Agenda Item **No. 5(h)**
Meeting of July 16, 2019

SUBJECT: Approving amendments to the Mission Bay South Signage Master Plan to: increase the limits of residential signage; decrease the clearance for fin signs; and to allow directional signage standards for residential and mixed use retail uses; an implementing action under the Mission Bay Subsequent Environmental Impact Report, a Program EIR; and adopting environmental findings pursuant to the California Environmental Quality Act; Mission Bay South Redevelopment Project Area

Attachment: Proposed 3E (Edwin M. Lee a Veterans and Family Community) Signage

Proposed 3E Signage

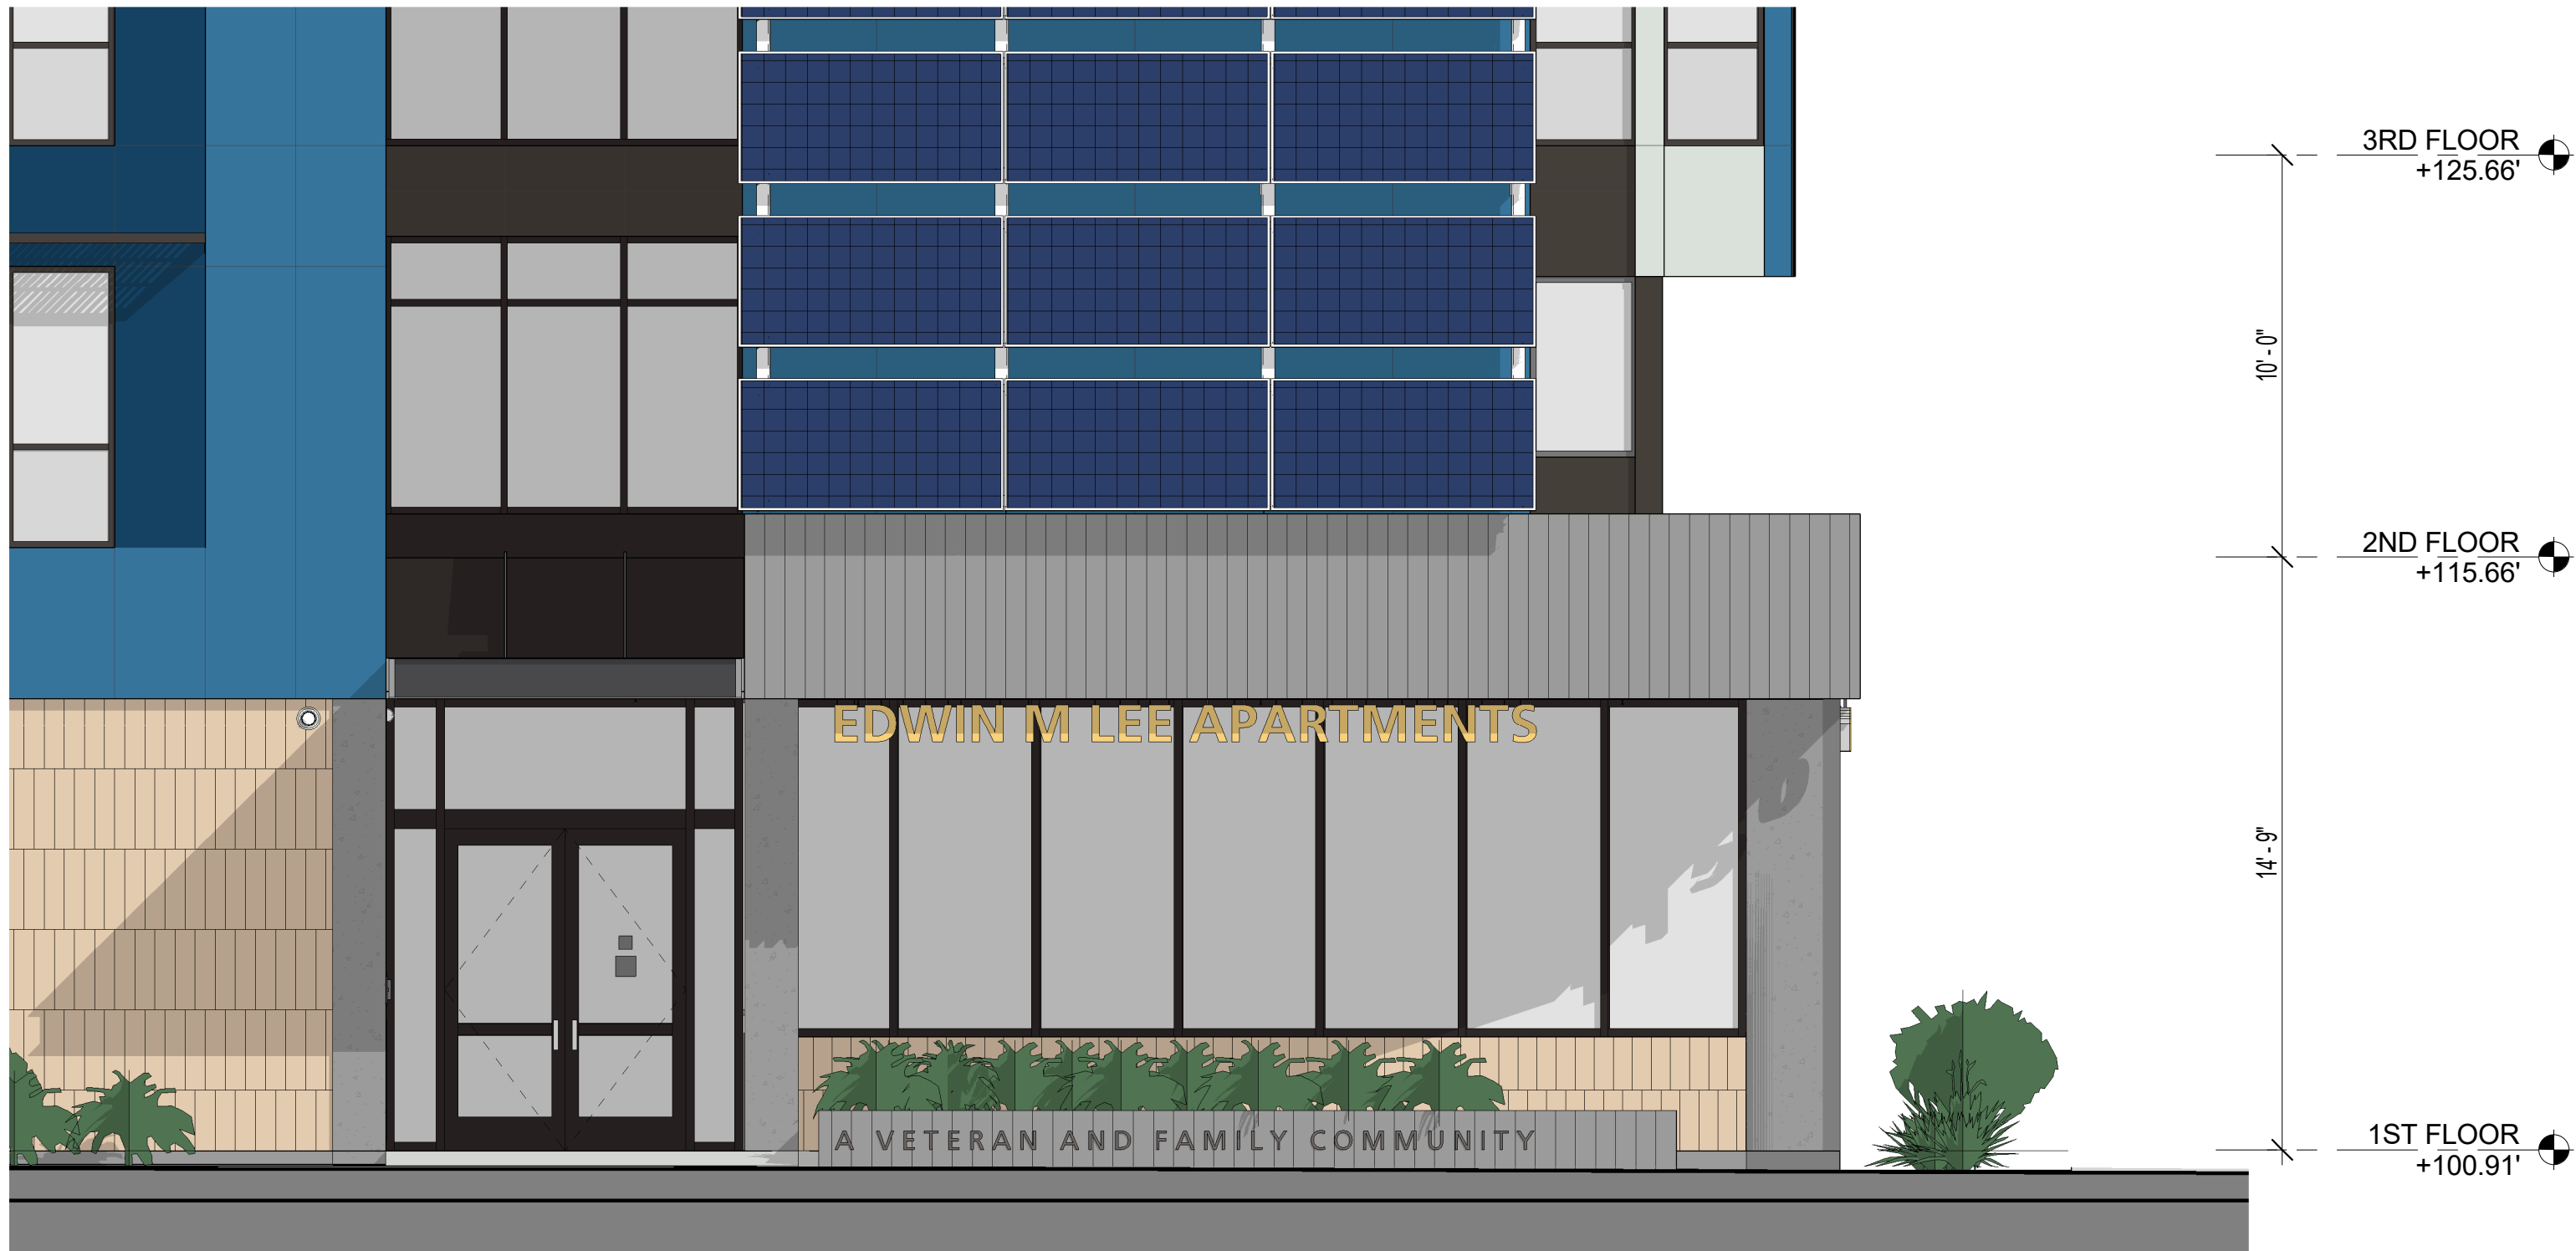
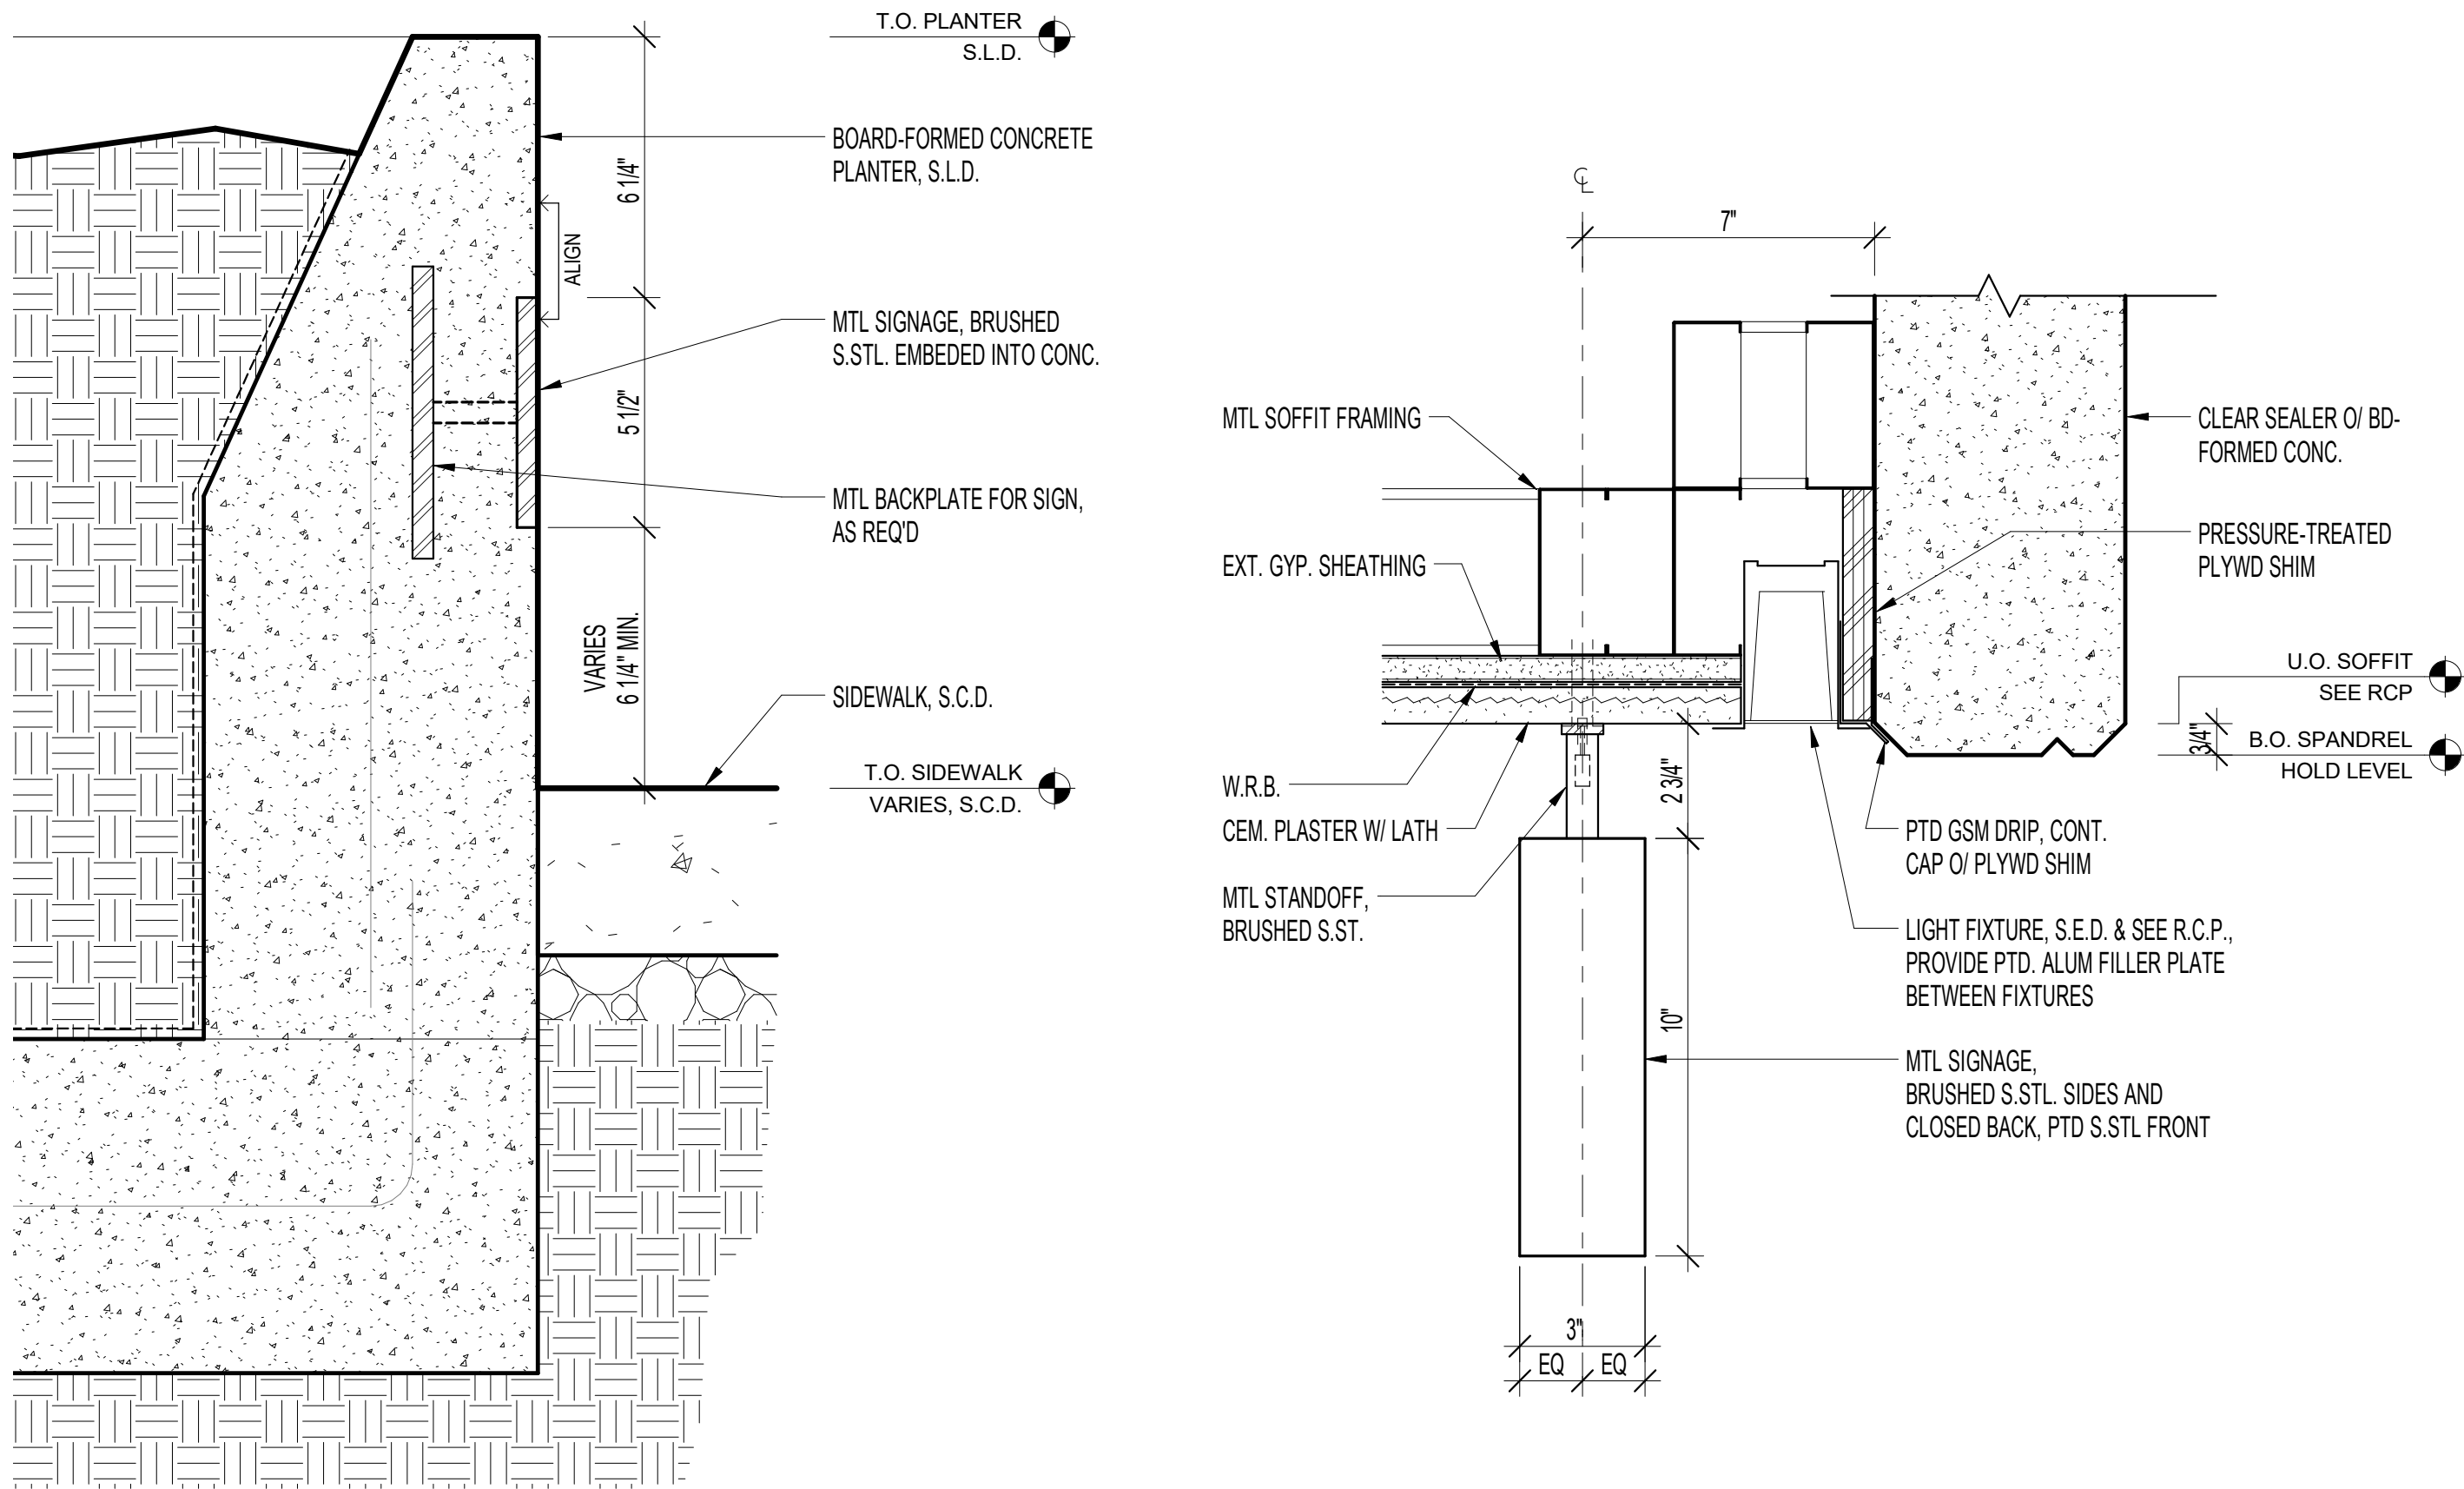
After reviewing the proposed signage for the affordable housing nearing completion on Block 3E, OCII staff determined that some of the standards are too limiting on the practical signage needs of some projects. Therefore, OCII is requesting approval of the following amendments to the Signage Master Plan: to increase the limit of residential signage on each parcel to a maximum of fifty square feet of sign area with no single street frontage exceeding thirty square feet and no individual sign to exceed fifteen square feet; to decrease the lower edge of commercial / industrial, hotel and mixed use retail fin signs from twelve feet to ten feet above the sidewalk; and to establish directional standards for residential and mixed use retail uses ("Master Signage Plan Amendments"). The proposed

The current residential standards allow for identification signage at a maximum square footage to be placed on each parcel street frontage with a slightly larger amount on 3rd and 4th streets including nameplates, wall signs and awning signs. Many projects have multiple or longer building names associated with a benefactor, a member of the community being honored, or property development firm. The current sign limits are too small and do not allow longer building names to be effectively communicated to visitors and pedestrians or vehicles passing by. Mission Bay South Block 3E, an affordable housing project, is proposed to be named after the late Mayor Lee (see attached); the current standard does not allow the building name, Edwin M. Lee a Veterans and Family Community, to be at implemented at a legible scale. The current and proposed amendment read as follows:

- The maximum signage program sign area allowed per parcel shall be 50 square feet with no single street frontage exceeding 30 square feet. Each individual sign shall not exceed 15 square feet.
